Subject: Dresden Station Units 2 & 3  
Quad-Cities Station Units 1 & 2  
Proposed Amendment to Facility  
Operating License Nos. DPR-19,  
DPR-25, DPR-29 and DPR-30 Associated  
with Reanalysis of the Loss-of-  
Coolant Accident  
NRC Docket Nos. 50-237/249/254/265

Pursuant to 10 CFR 50.59, Commonwealth Edison proposes to amend the Dresden Station Units 2, 3 and Quad-Cities Station Units 1, 2 Technical Specifications regarding revised Maximum Average Planar Linear Heat Generation Rate (MAPLHGR) limits associated with reanalysis of the Loss-of-Coolant Accident. Reference (a) transmitted the General Electric Report NEDO-24046, dated August 1977, entitled "Loss-of-Coolant Accident Analysis Report for Dresden Units 2, 3 and Quad-Cities Units 1, 2 Nuclear Power Stations (Lead Plant)." NEDO-24046 documents the completion of the ECCS reevaluation and forms the basis for the revised MAPLHGR limits.

MAXIMUM AVERAGE PLANAR LINEAR  
HEAT GENERATION RATE (MAPLHGR)  
VS. PLANAR AVERAGE EXPOSURE

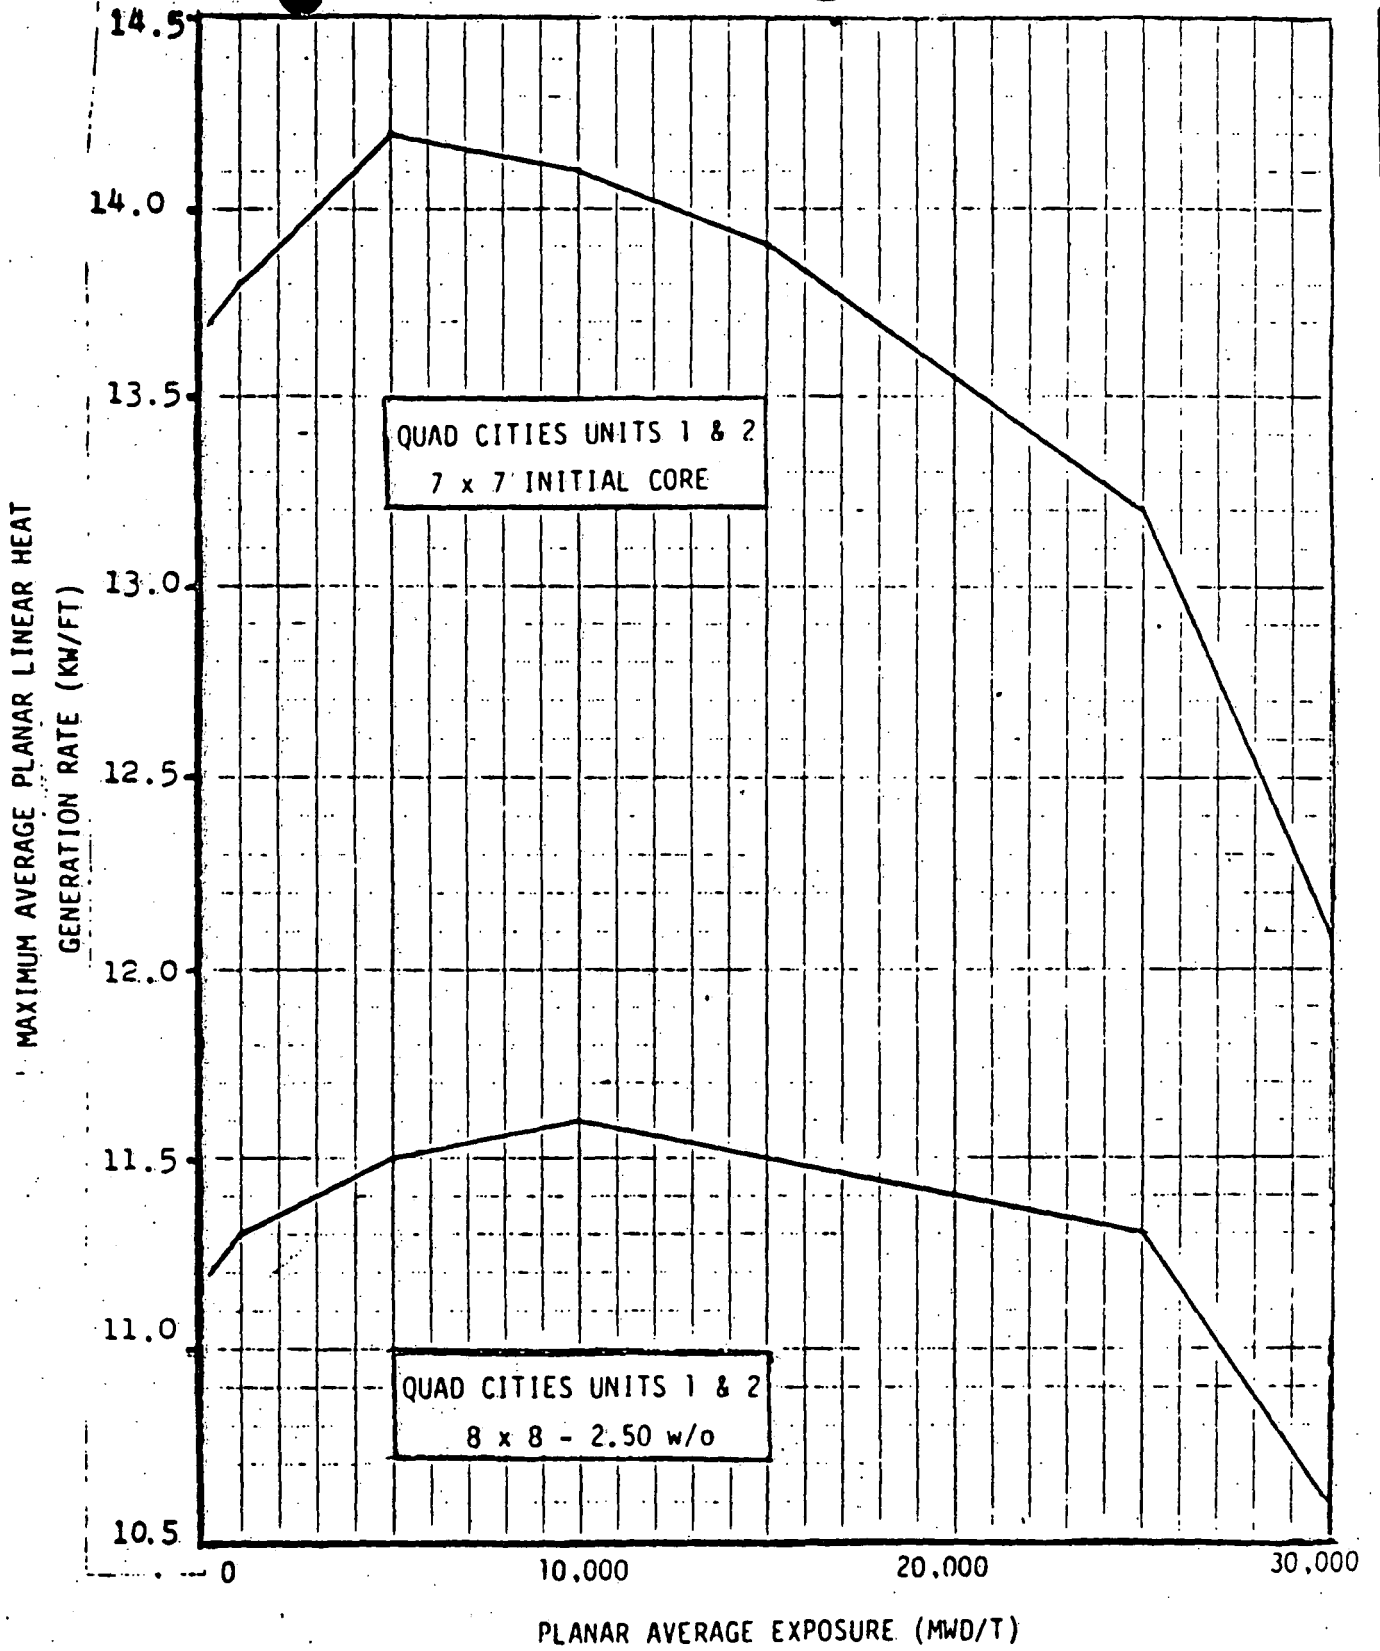
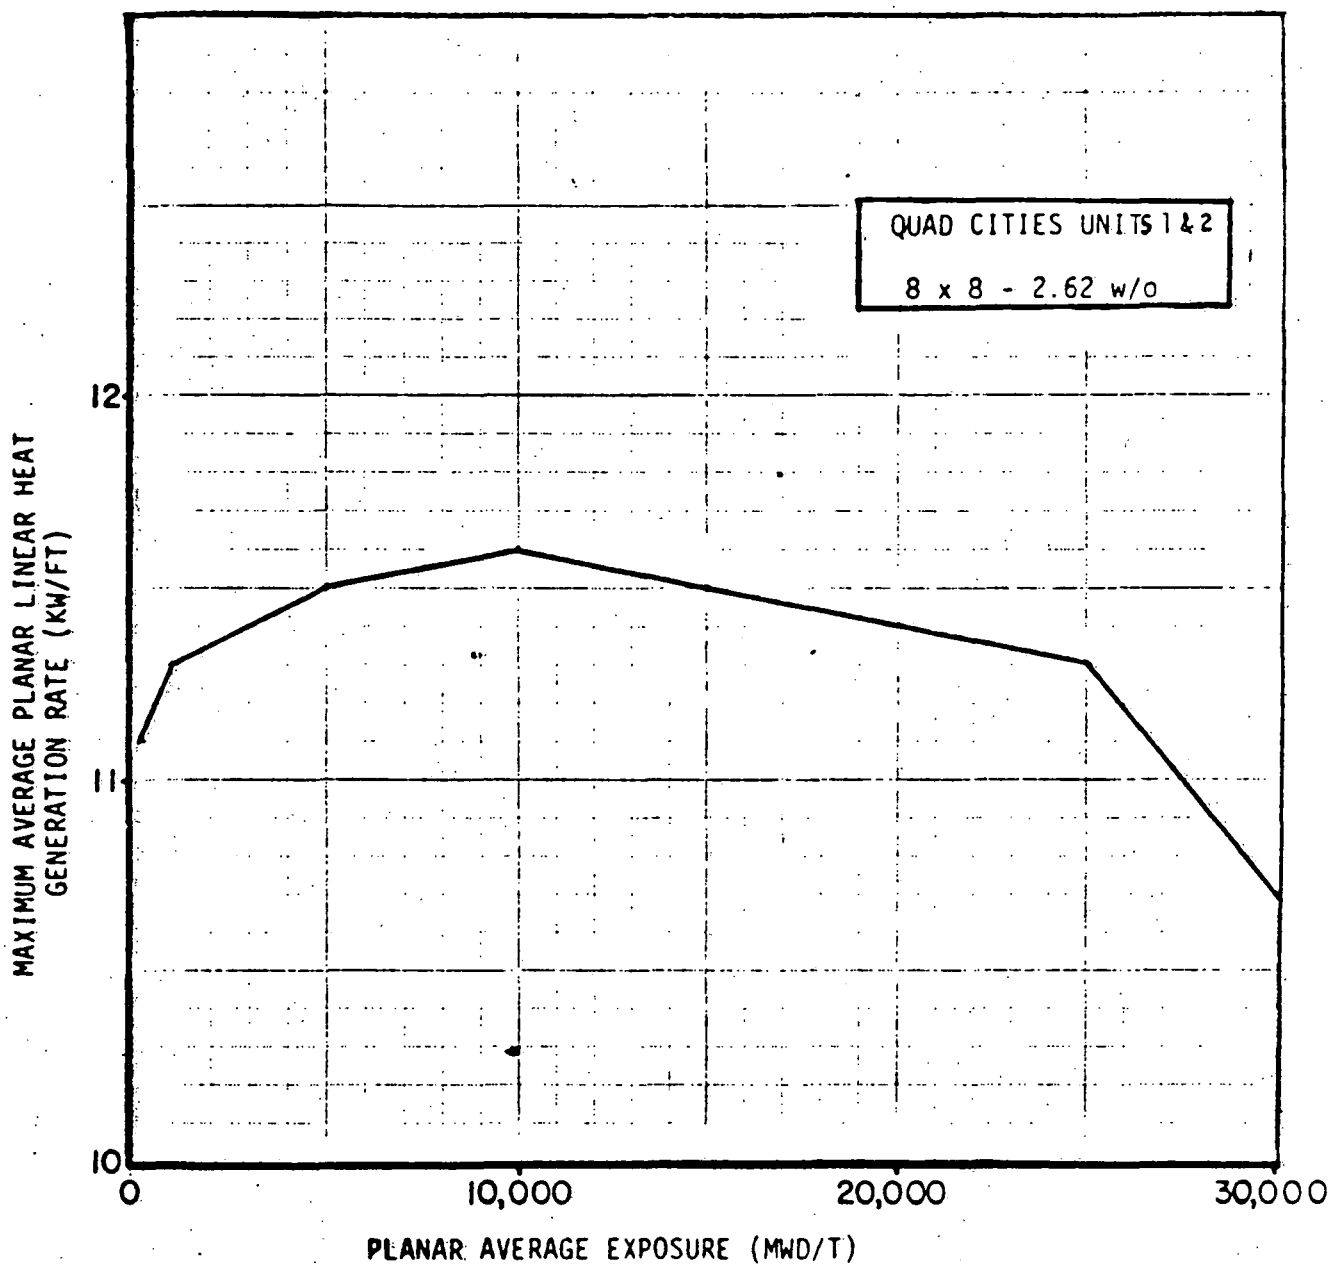
Attachment I contains the proposed changes for Dresden Units 2 & 3 and Attachment II contains the proposed changes for Quad-Cities Units 1 & 2. The referenced NEDO-24046 document and the attached Technical Specification changes have received onsite and offsite review and approval.
